## Application for Works Approval Amendment

<b>Works Approval Number</b>	W6209/2019/1
<b>Works Approval Holder</b>	Hastings Technology Metals Limited
<b>ACN</b>	122 911 399
<b>File Number</b>	DER2019/000040
<b>Premises</b>	Yangibana Rare Earths Project Legal description - Mining Tenements G09/14, M09/158, M09/157, G09/18, G09/17, G09/20 and M09/161 WEST LYONS RIVER WA 6705 As defined by the Premises map attached to the Revised Works Approval
<b>Date of Report</b>	10 June 2022
<b>Decision</b>	Revised works approval granted

#### **A/SENIOR MANAGER, RESOURCE INDUSTRIES REGULATORY SERVICES**

Figure 1: Updated location of process plant

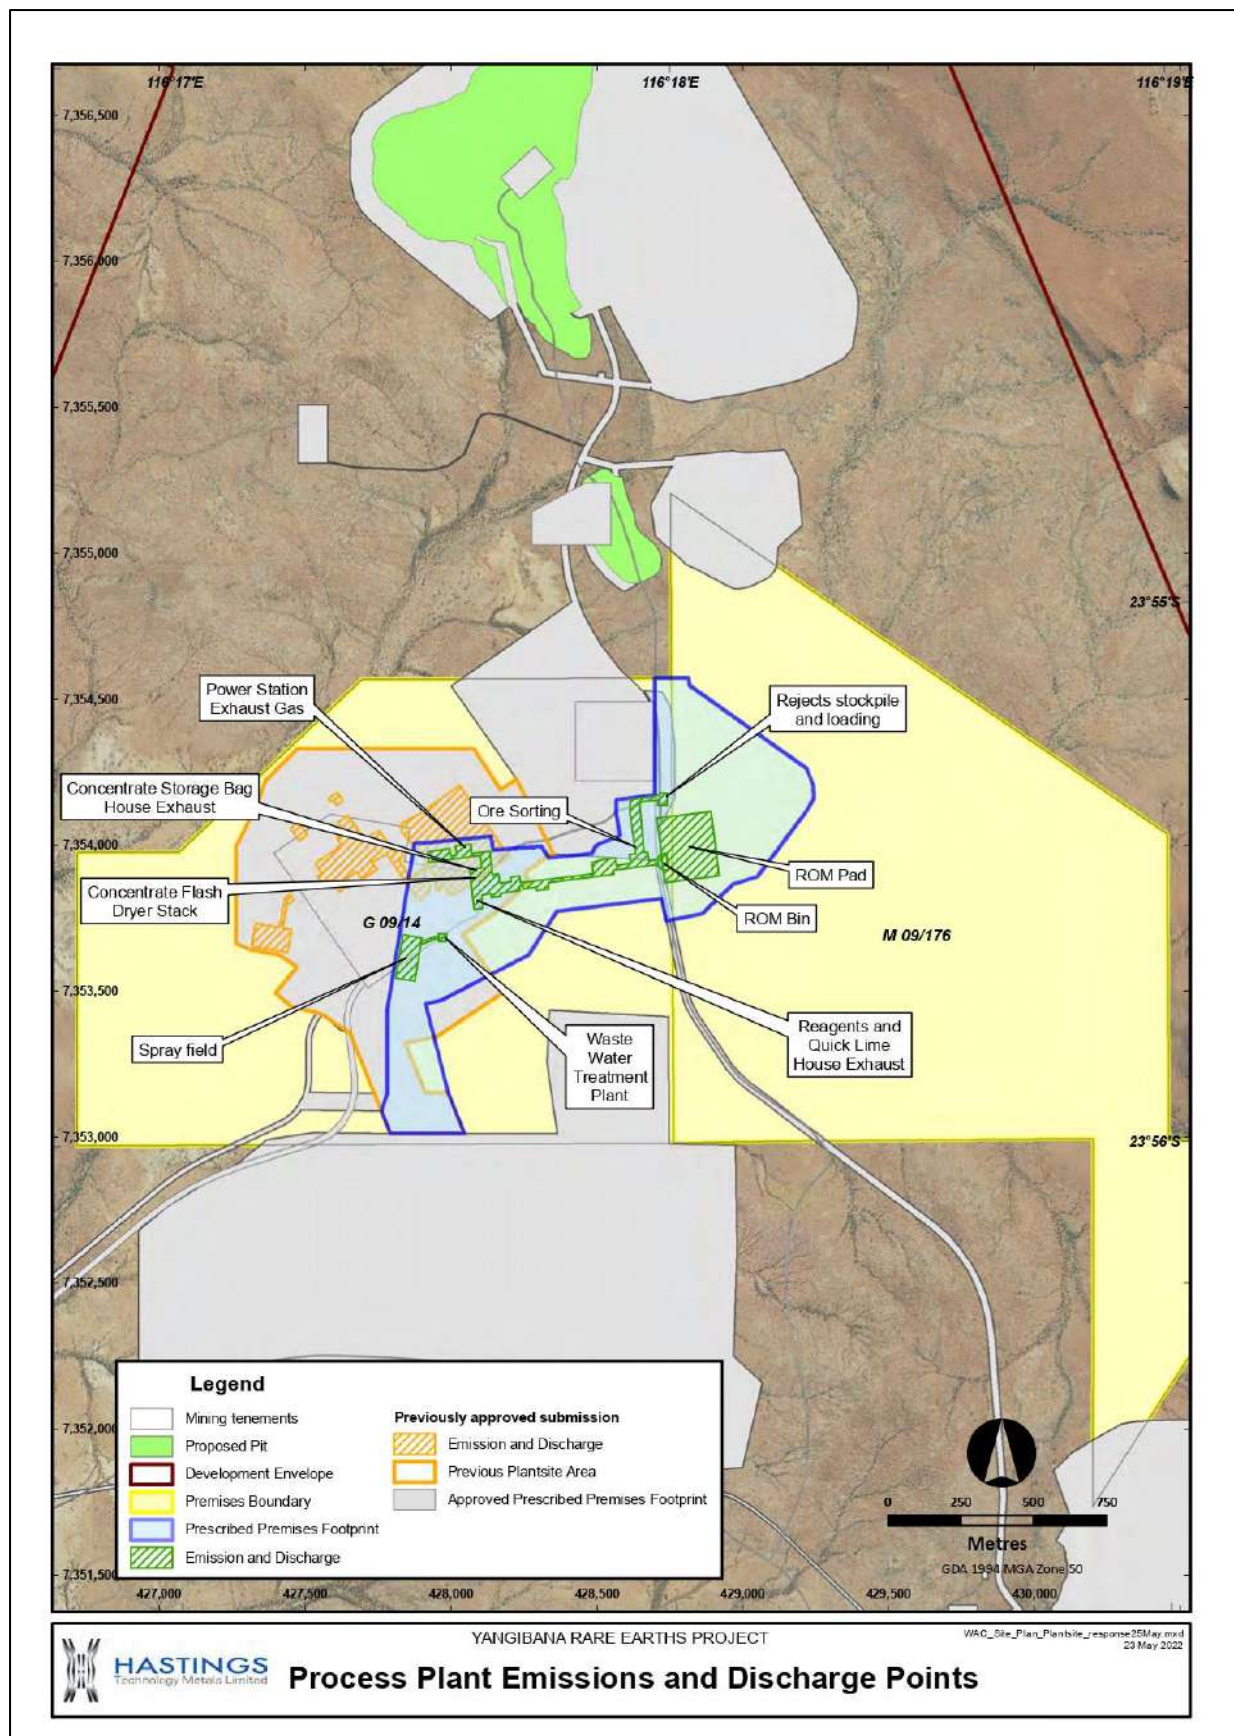
The location of the process plant is proposed to be shifted to approximately 750 m to the east of its approved location (Figure 1). The change in location was to more favourable ground conditions for construction activities and to reduce distance to transport ore from the mining operations to the process plant, which represented a significant reduction in operating expenditure.

**Figure 3: Current layout plan for Beneficiation TSF and Hydromet TSF**

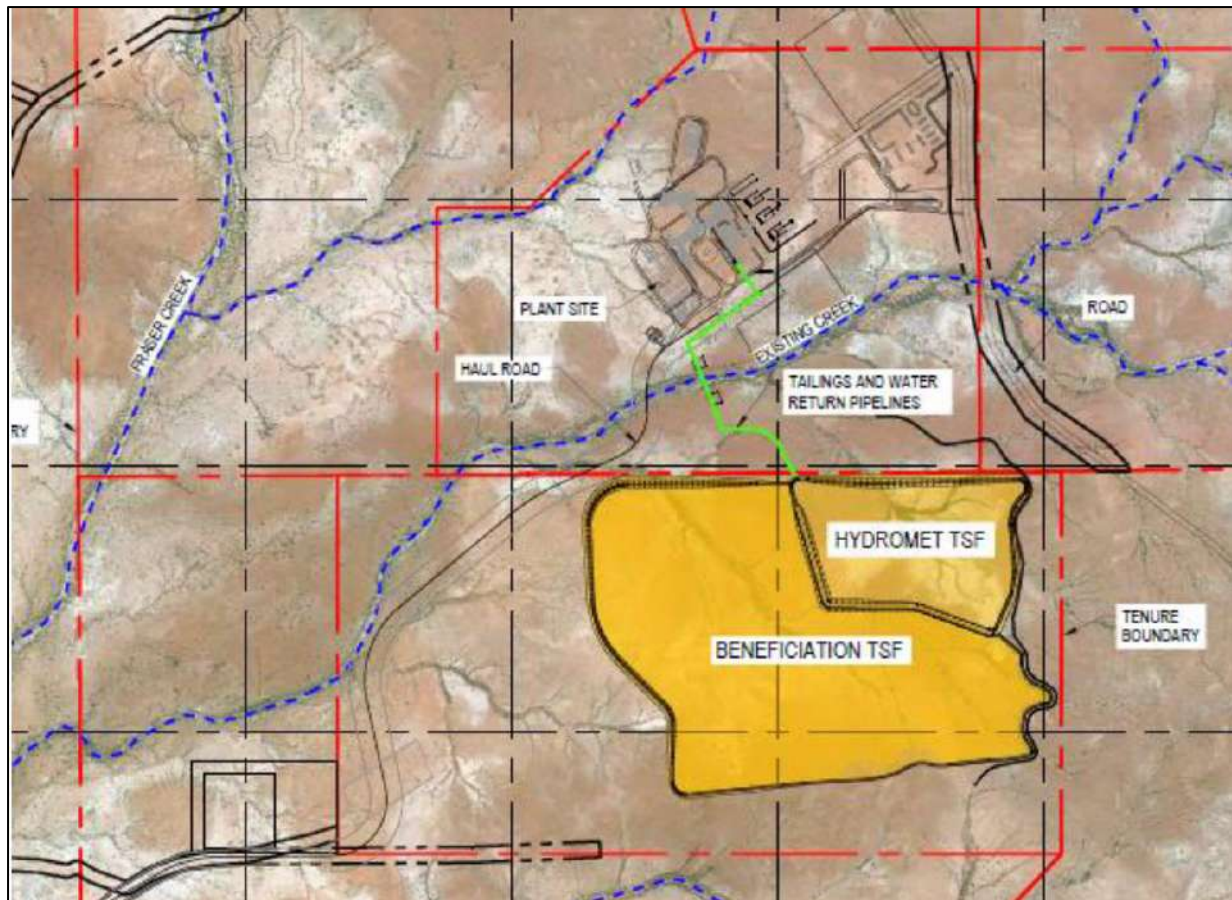
Based on correspondence with the Works Approval Holder during the assessment of this amendment, the department understands that the Works Approval Holder intends to retain the Hydromet tailings storage facility (TSF) at the premises. The Hydromet TSF was designed to abut the north-eastern portion of the larger Beneficiation TSF (Figure 3) and would receive tailings from the hydrometallurgical plant and barren liquor (wastewater from the hydrometallurgical process and reverse osmosis effluent from the wastewater treatment plant). The Works Approval Holder has proposed to transport tailings from the offsite hydrometallurgical plant and deposit them into the Hydromet TSF.

Due to potential changes to either tailings characteristics or deposition method, an updated assessment is required to assess and manage the risk of emissions and discharges at the Hydromet TSF. At the time of this amendment, the Works Approval Holder is still in the process of updating their TSF design and operational strategy. As such, the Delegated Officer has decided to remove the authorisation for time-limited operation of both the Beneficiation TSF and Hydromet TSF from the works approval. Time-limited operation authorisation for the Beneficiation TSF was also removed as it shares an embankment with the Hydromet TSF and will likely be affected by the updated TSF design.

Under the amended works approval, the Works Approval Holder is still allowed to construct the TSFs in accordance with the approved design. However, the department notes that the approved design may not necessarily be fit-for-purpose due to potential changes to TSF design, tailings characteristics or deposition method. The department understands, through verbal communication with the Works Approval Holder, that construction of either TSFs will not commence until the updated TSF design has been finalised and its construction and time-limited operation have been assessed by the department under a separate, future amendment to works approval W6209/2019/1.

**Figure 4: Proposed location for wastewater treatment plant and sprayfield in relation to relocated process plant**

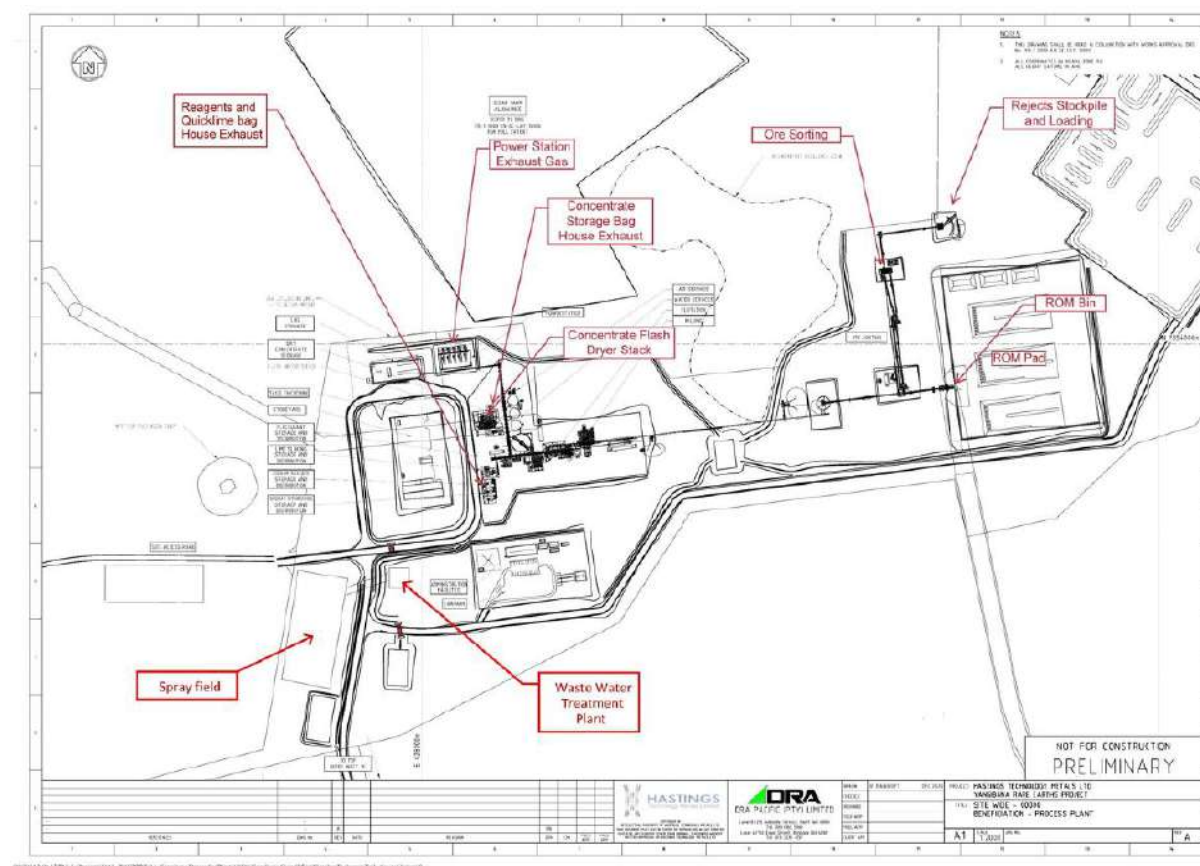
The construction of a WWTP and associated sprayfield was authorised under works approval W6209/2019/1 to treat sewage from the ore processing plant and mine support buildings. Due to the shift in location for the ore processing plant (refer to Section 2.2.1), the location of the WWTP and sprayfield will also need to be relocated (Figure 4).

There are no proposed changes to the technical specification and capacity of the WWTP and sprayfield. The system will still comprise of a five-stage Bardenpho-activated sludge treatment plant designed treat effluent to Western Australian Class C standards.
